#941320 HIGH-SPEED BALL-BEARING 13x19x4 RUBBER & STEEL SEALED (2)

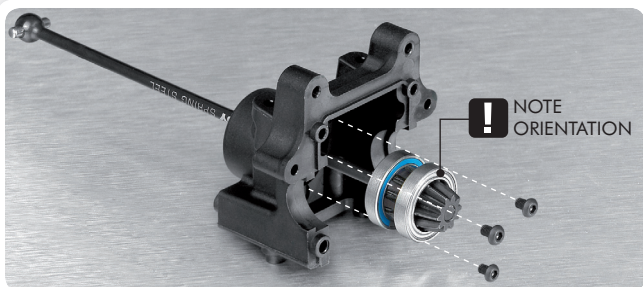
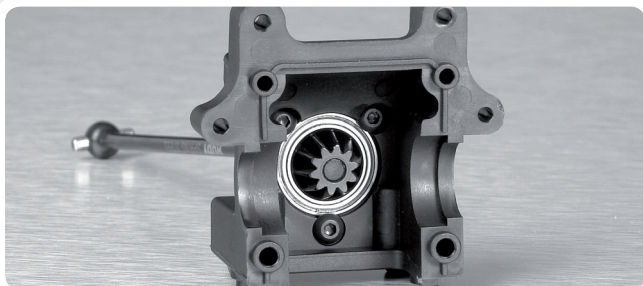
The 13x19 ball-bearings in the pinion gear assembly carry extreme load, and in some extreme situations the rubber seal of the ball-bearing installed in the bulkhead housing may become dislodged. To prevent this, XRAY has developed a new ball-bearing which has a steel seal on one side and a rubber seal on the other side.

- 1 Install the ball-bearing with the steel seal facing inside the housing as shown.

- 2 Assemble the ball-bearings in the housing as per the XB808 Instruction Manual (page 10/11, step 2).
